ACCESSION NBR: 8212170173 DOC. DATE: 82/12/09 NOTARIZED: NO DOCKET #  
 FACIL: 50-397 WPPSS Nuclear Project, Unit 2, Washington Public Power 05000397  
 AUTH. NAME AUTHOR AFFILIATION  
 BOUCHEY, G. D., Washington Public Power Supply System  
 RECIP. NAME RECIPIENT AFFILIATION  
 SCHWENCER, A., Licensing Branch 2

SUBJECT: Responds to NRC Question 010,066 re pipe break in BWR scram  
 sys (NUREG-0803). Response to Questions 010,067 - 010,074  
 will be submitted under separate cover during Dec 1982.

Subject: NUCLEAR PROJECT NO. 2  
RESPONSE TO NRC QUESTION  
010.066, NUREG-0803

## RESPONSE TO NRC QUESTION 10.66(4.6)

FIGURE 1

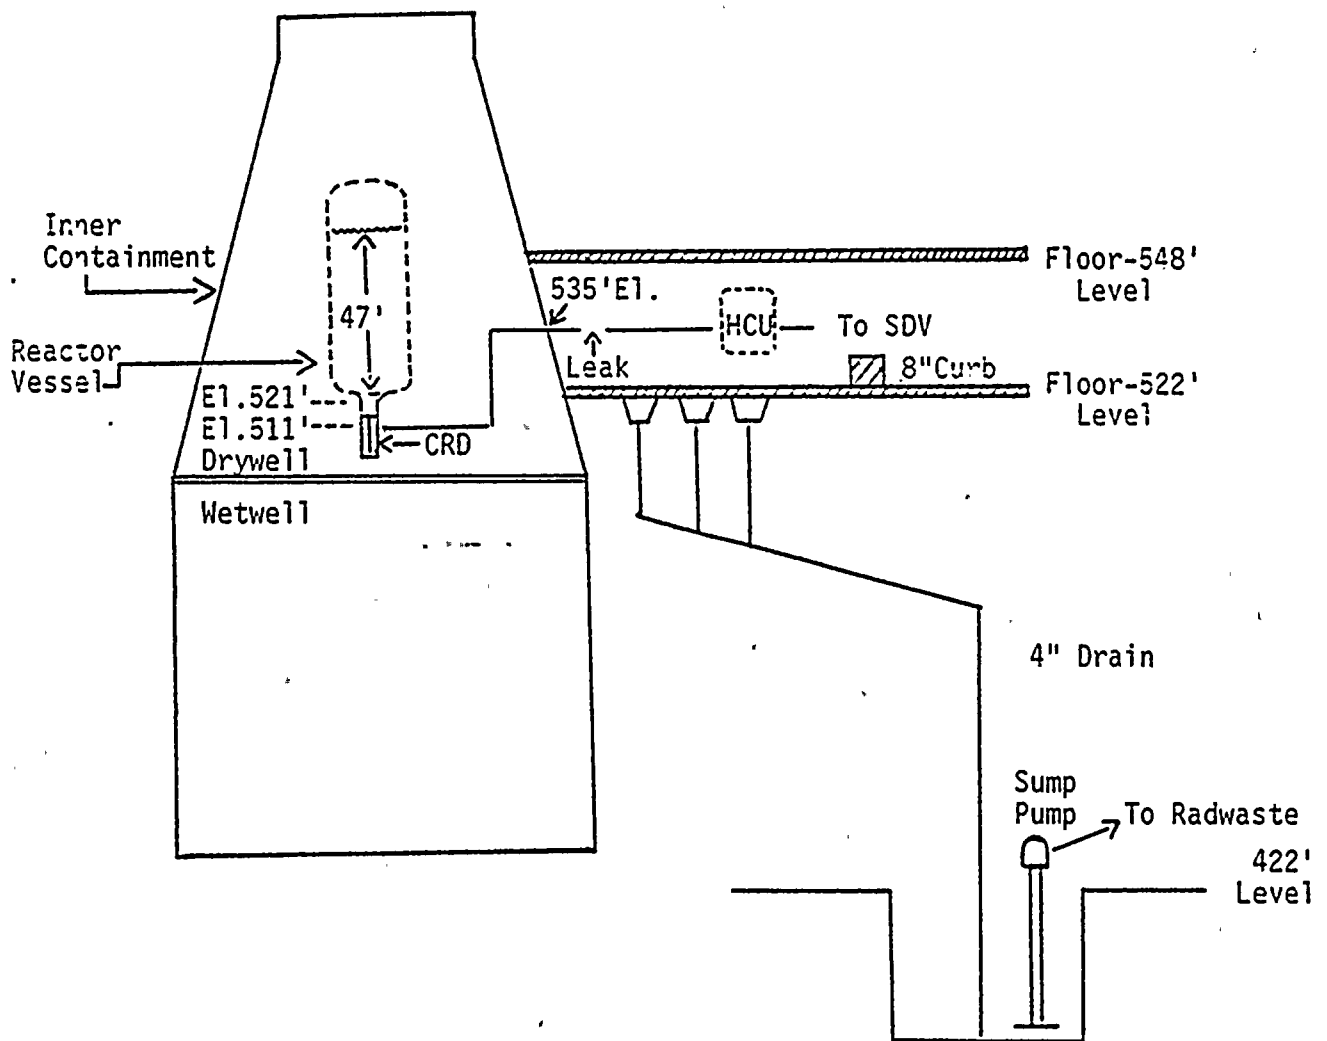
- I. Taking no credit for seals and assuming no operator actions inside of the control room for 20 minutes (30 minutes for the first operator action outside of the control room plus five minutes for each additional action), provide the following information for a non isolable break in the CRD piping between the containment penetration and the first isolation valve.

- IV. Assuming that the sumps are inoperative for the event in Part I (since they are not seismic Category I, Class 1E), provide maximum water level in the compartment. Verify that no equipment required to bring the plant to a safe condition will fail as the result of internal flooding. Verify that no personnel radiation hazard will exist due to wading through reactor coolant.

A simplified diagram of the postulated line rupture is shown in Figure 1. It is assumed that a complete severance of a withdrawal line occurs, following a reactor scram, at a location between the Reactor Containment and the first isolation valve (in HCU). There is no back-flow through the break due to a check valve between the break location and the scram discharge volume (SDV). Therefore, the only leak out of the break is the reactor coolant that can leak around the CRD piston seals. This leakage is normally about 2 gpm and can be as high as 5 gpm with badly worn seals. The stipulation in the Question 10.66 above that no credit for seals be taken is an unrealistic conservatism. However, GE tests show that with seals completely missing, at operating pressure, the leakage is a maximum of 10 gpm. This value is used as the initial leak rate.

- k. Differential elevation: See Figure 1.
- l. Total Flow Resistance: Total pipe resistance was neglected for the low flow rates encountered. The hydrostatic analysis accounted for orifice pressure drop at the CRD, see Item 3.a below.

pump cavitation . . ." to refer to the sump pump to which the reactor leakage drains (see Figure 1). If the total leakage (assuming no flashing) drains to the sump, its water level would be 0.2". Therefore, pump cavitation is not an issue as the sump pumps are not required to prevent flooding.

FIGURE 2: Temperature Versus Time With 100° F/HR Cooldown

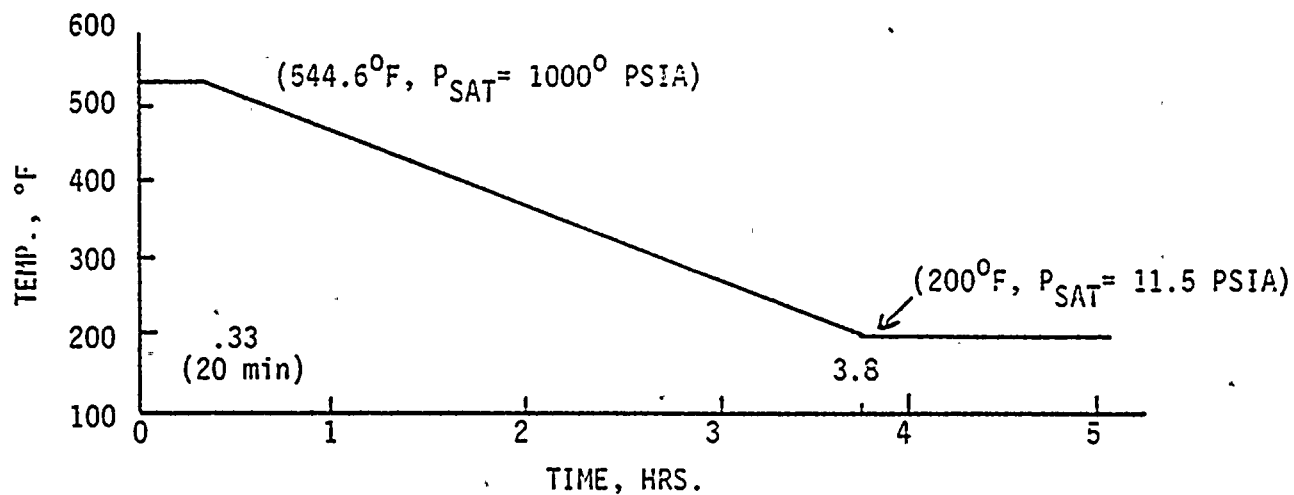
Reactor Coolant - Mass flow rate out of the break as a function of time ( $= f(t)$ )  
- Temperature  $= f(t)$   
Compartment - Temperature  $= f(t)$   
- Pressure  $= f(t)$   
- Humidity  $= f(t)$   
- Airborne Radioactivity level  $= f(t)$

1. a. Type of fluid: Water
  - b. Temperature: }
  - c. Pressure: } See Figure 2
  - d. Source of fluid: Reactor vessel
  - e. Flow Rate: See Figure 3
  - f. Pipe internal diameter: }
  - g. Wetted Perimeter: }
  - h. Total pipe internal volume: }
  - i. Exit flow area: }
  - j. Area of flow restriction: 1.19 x 10<sup>-4</sup> ft<sup>2</sup> - equivalent area for 10 gpm leak at 1000 psia.
- Not applicable,  
See Item 1.j below.
